**86130A-11**

# S E R V I C E N O T E

## 86130A BitAlyzer Error Performance Analyzer

**Audio Circuit Modification if 86130A speaker stops working.**

**Figure 1** – Location of modifications on A5A3 CPU Distribution Board 86130-60025

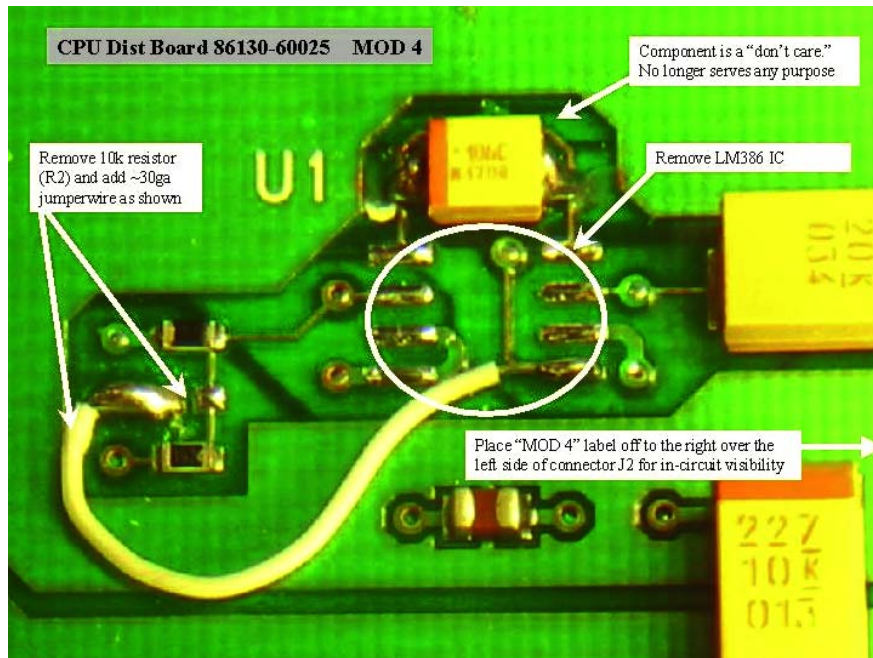
**Step 1** – Modify A5A3 CPU Distribution Assembly 86130-60025 – refer to Figure 1 below.

- a. Remove R2 10K Resistor.
- b. Remove LM386 IC.
- c. Add 30ga jumper as shown.
- d. Affix MOD4 label to assembly.

**Figure 2** – Location of modification on A5A1 CPU (Radisys) Board 86130-60062

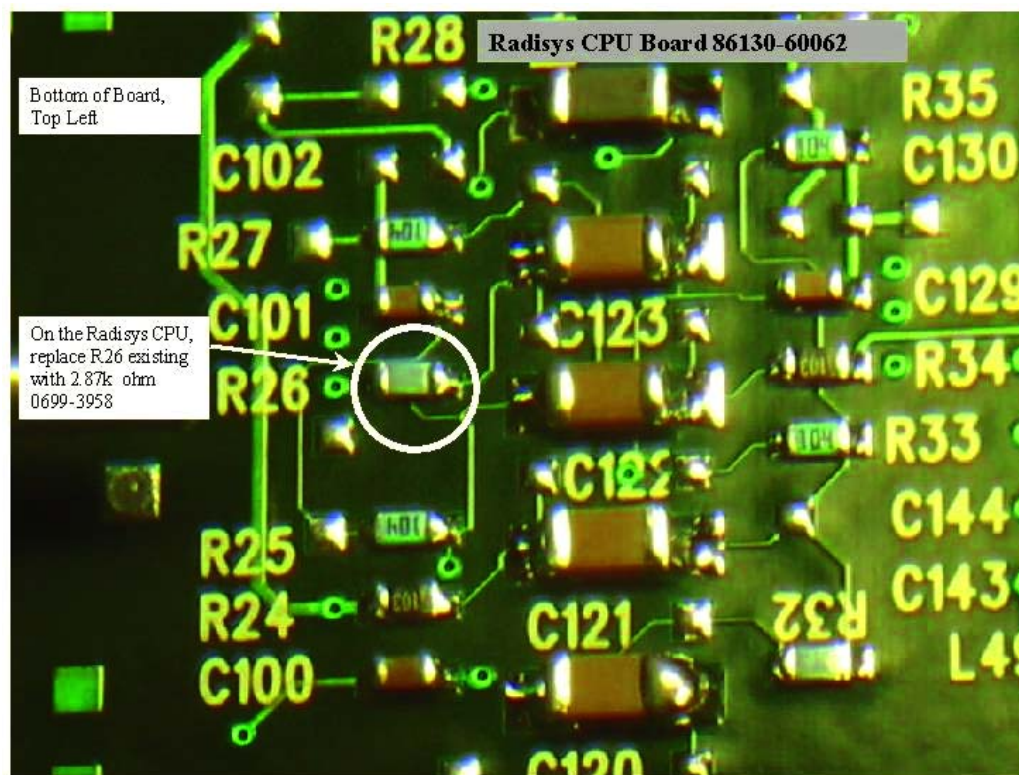
**Step 2** – Modify A5A1 CPU (Radisys) Board 86130-60062 – refer to Figure 2 below.

- a. Remove R26 46.4k ohm resistor.
- b. Add R26 2.87 k resistor (PN 0699-3958).
